From: [Max Wemyss](#)
To: [Alison Fournier](#)
Cc: [Greg Harrison](#); [David Recor](#); [Brian Donovan](#); [Suzette Sibble](#); [Nguyen Tran](#); [Daniel Keester](#); [Pamela Stanton](#); [Martha Lawson](#)
Subject: RE: Questions about potential Text Amendment
Date: Tuesday, February 21, 2023 9:56:00 AM
Attachments: [Text amendment and map revisions.pdf](#)
[155.3708.K.3.pdf](#)
[Zone B Levels 7-10.pdf](#)

To: Development Services
From: Commissioner Alison Fournier
Re: Zone B & D Text Amendment and Revised Maps

OLD TOWN TOWERS
POMPANO BEACH, 33060

LEVELS 7-10 - ZONE B

Figure: Building Line

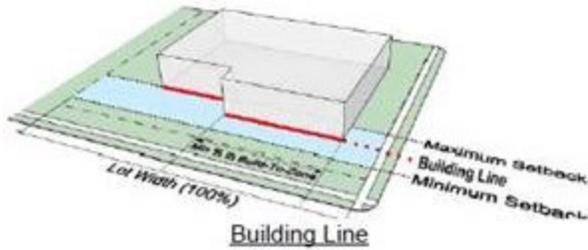
Q1: Which side of the Zone B building is considered the "front building line"? Is it the North, Primary St?

A building line the line of the façade that runs parallel to a lot line. Since the subject development (Zone B) is a full block development with four street frontages all of the elevations contain a front building line. A front building line is the proposed minimum setback of a façade from a street facing lot line. Within the Transit Oriented Overlay Districts buildings along both a front and a streetside property line are treated the same way regarding building design features such as setback, building length, and active use requirements.

1 LEVEL 7 - ZONE B
A-1.10 SCALE: 1/16" = 1'-0"

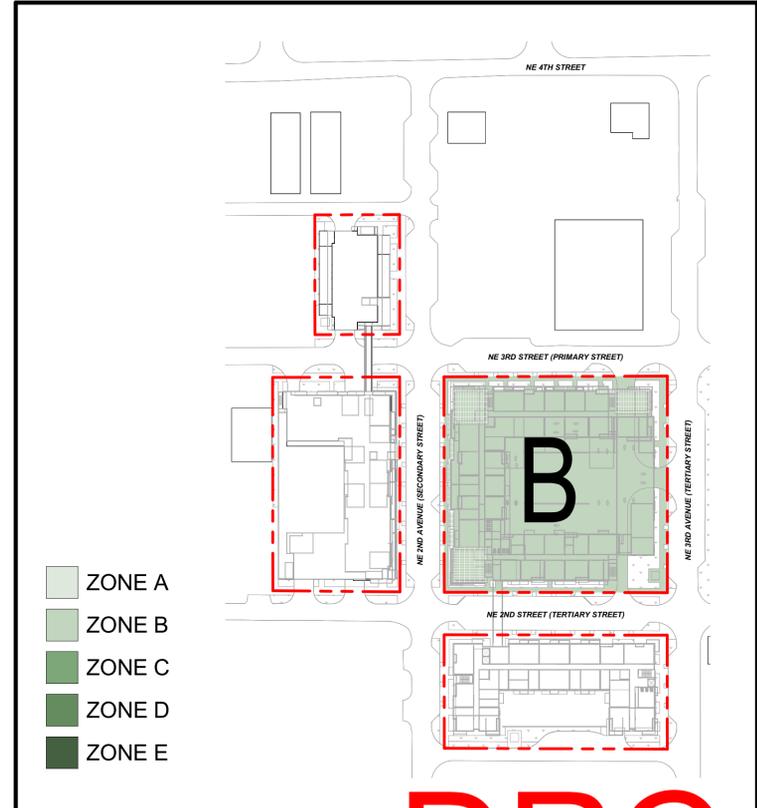
Q2: What is the calculation of the sq footage for levels 7-10 of Zone B?

Q2: What is the calculation of the sq footage for levels 7-10 of Zone B?

31,000 square feet per floor for levels 6-10, as the “tower” begins with level 6. The permitted maximum size of a residential floorplate within a tower is 32,500 square feet. The total proposed for levels 6-10 is 155,000 square feet cumulative.

With the proposed amendment a developer would likely provide the 80% reduction and not create a setback from the building line of the podium. A frequent complaint of developers is the column alignment that is required to support a 20' setback for upper stories. A more frequently preferred layout (by developers) is one with units lining an amenity deck. The applicant has submitted the attached plan (Zone B Levels 7-10) which is exactly as I have described.
